City of Phoenix
PLANNING AND DEVELOPMENT DEPARTMENT

Addendum A
Staff Report Z-27-19-8
August 26, 2019

Request From: [S-1](#) (Ranch or Farm Residence District);
Approved [RE-35](#) PCD (Single-Family
Residence District, Planned Community
District) (15.24 acres), Approved [R1-10](#)
PCD (Single-Family Residence District,
Planned Community District) (65.03
acres), Approved [R1-8](#) PCD (Single-
Family Residence District, Planned
Community District) (67.89 acres),
Approved [R-3](#) PCD (Multifamily
Residence District, Planned Community
District) (15.66 acres).

Proposed Use: Single-family residential subdivision

Conceptual Site Plan date stamped August 16, 2019

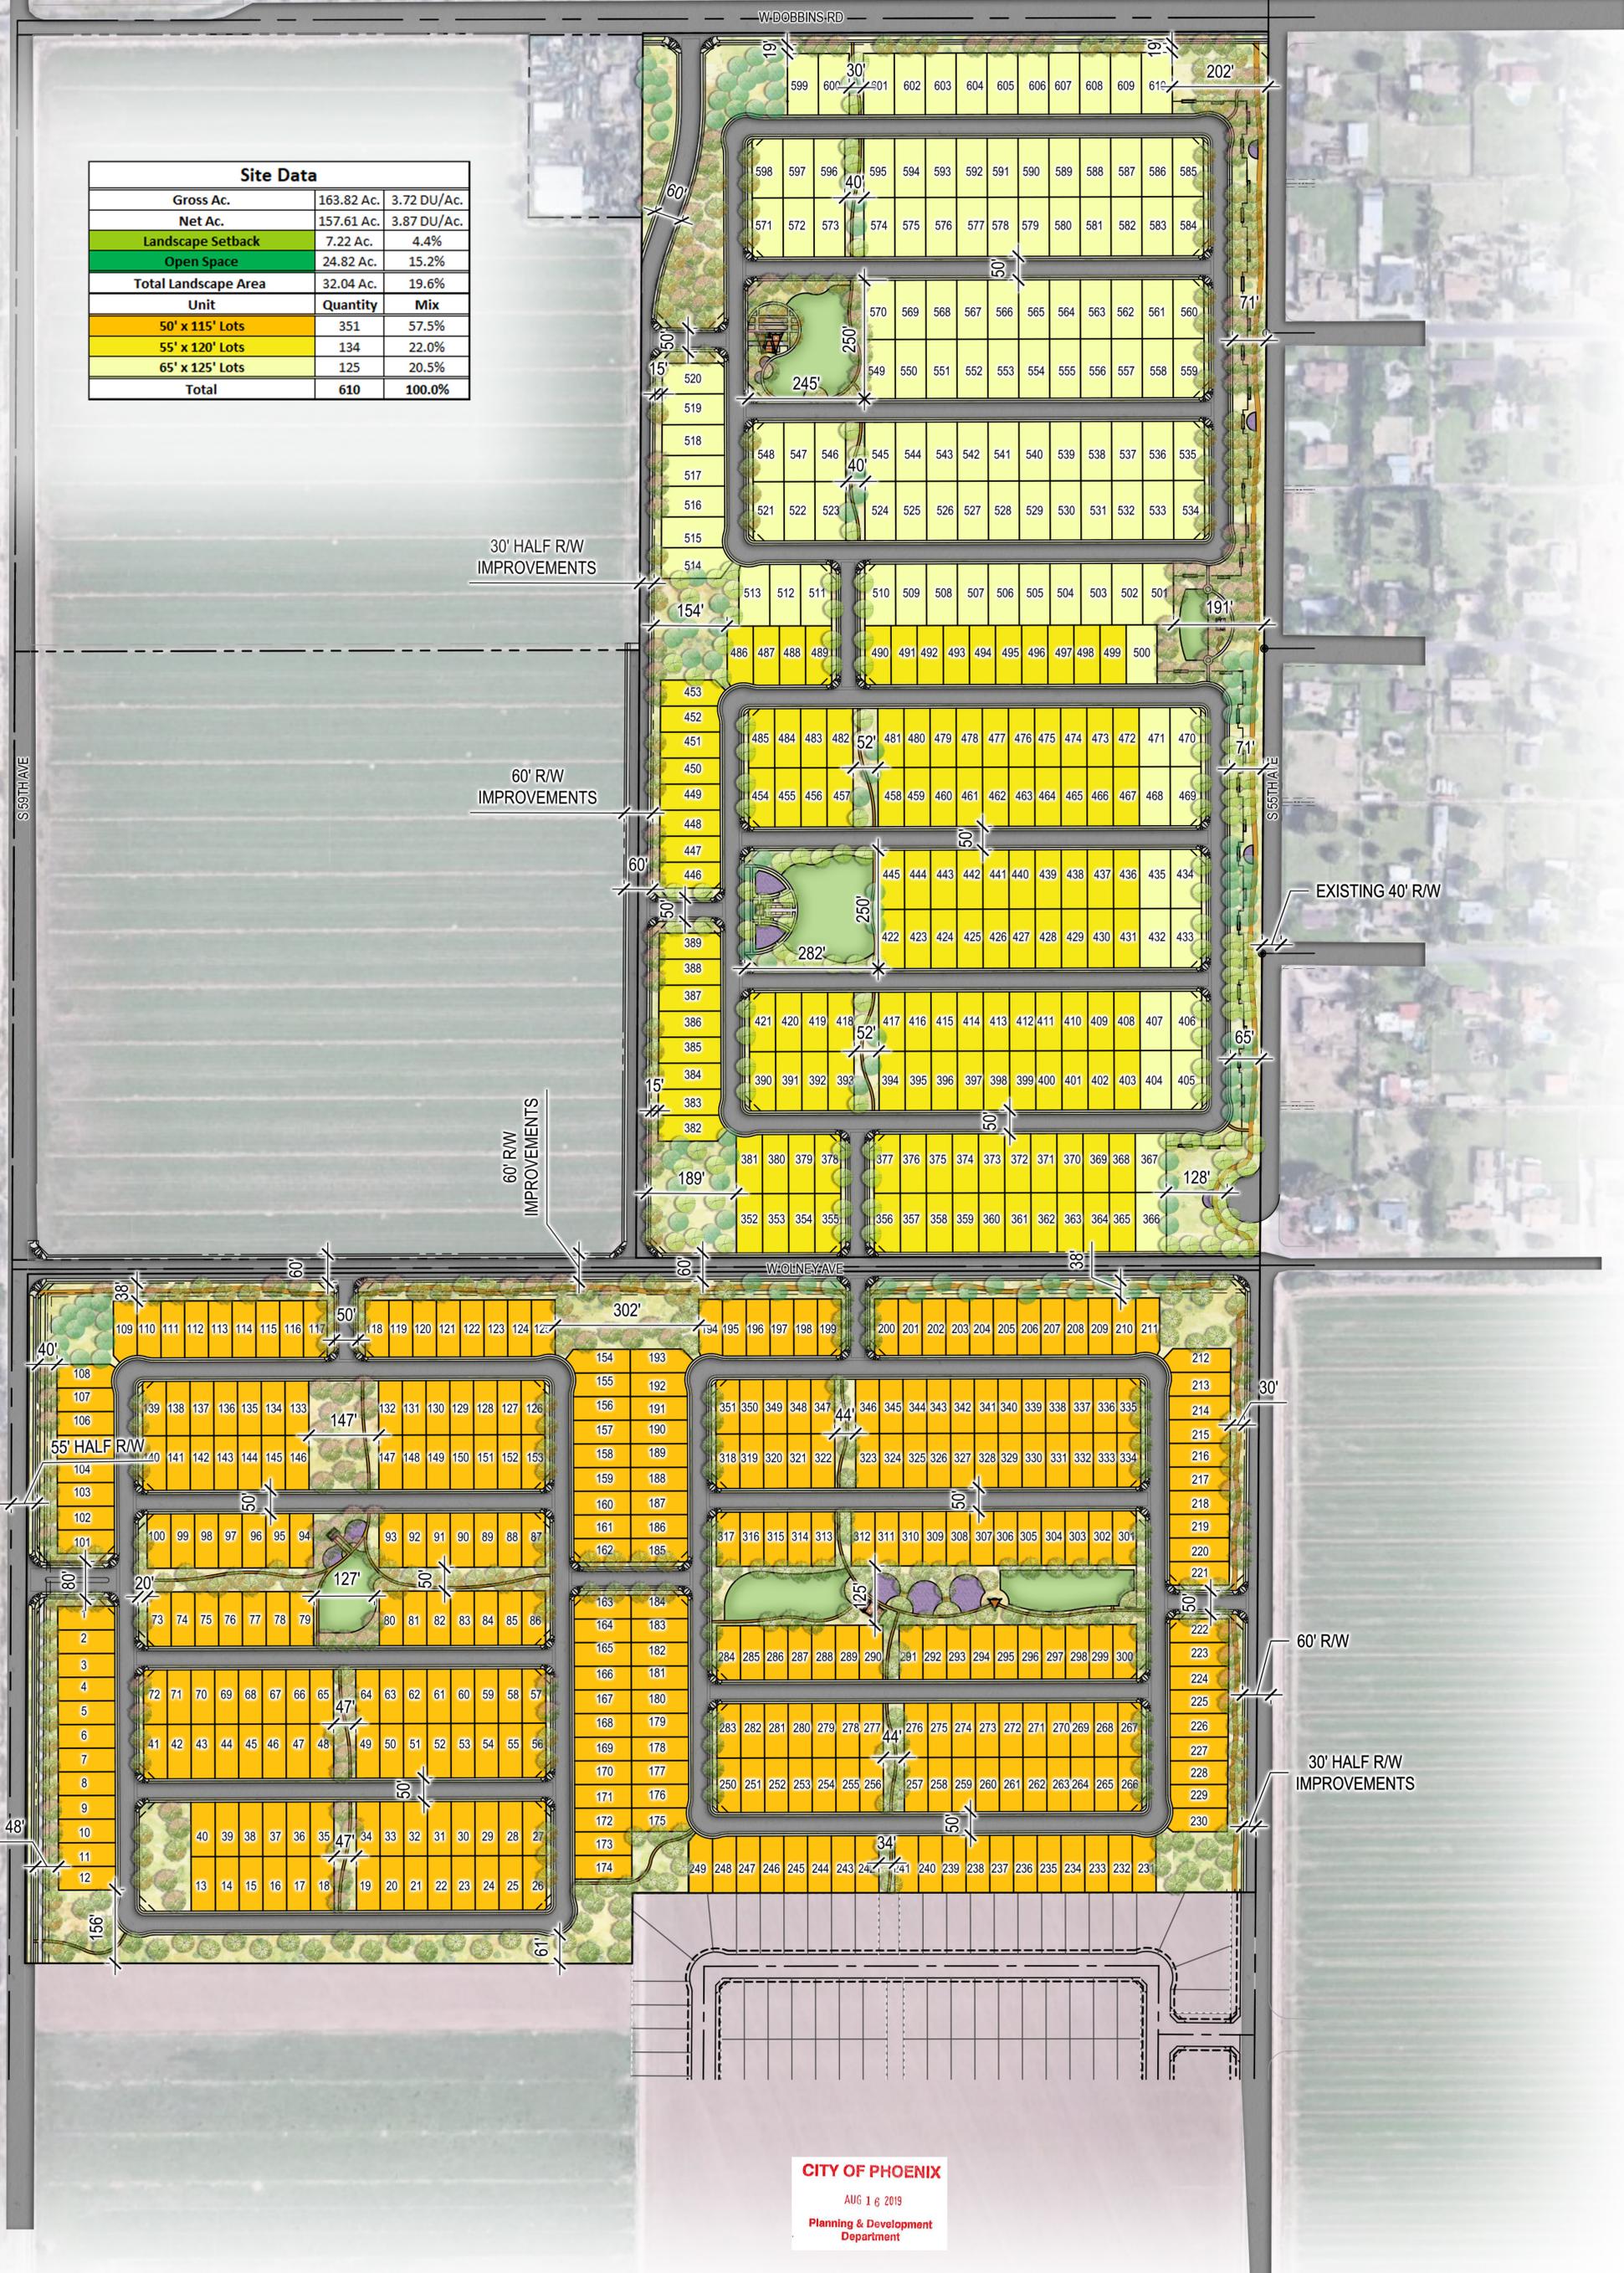
On August 16, 2019 the applicant provided an updated site plan which reflects the recommended stipulations from the July 8, 2019 Laveen Village Planning Committee meeting with the exception of the 18 percent open space. Changes include the removal of all 45 foot-wide-lots, the reduction in the number of units proposed from 628 to 610, minor changes to the Parks Master Plan, and a revised open space calculation.

- a) Stipulation No. 1: the total number of units permitted on the site. The updated plans depict 610 dwelling units rather than 628 and the stipulation is revised to reduce the total number of units permitted.
- b) Stipulation No. 6: the amenity programming of open space areas. The updated plan depicts minor changes to the Parks Master Plan in regard to the size of open space areas.

1. The development shall not exceed ~~628~~ **610** dwelling units.
2. North of Olney Avenue, the development shall be limited as follows and as approved by the Planning and Development Department:
 - a. Within 200 feet of the east property line, building height shall be limited to one story and 20 feet.
 - b. Within 200 feet of the east property line, the minimum perimeter building setback shall be 70 feet.
3. There shall be no lots less than 55 feet wide north of Olney Avenue AND NO LOTS LESS THAN 50 FEET WIDE SOUTH OF OLNEY.

6. There shall be a minimum of 5 evenly dispersed amenity areas situated in the common open space areas with the programming of amenity features being in general conformance with the Estrella Crossing Parks Master Plan date stamped ~~May 10, 2019~~ **AUGUST 16, 2019**, as approved by the Planning and Development Department.
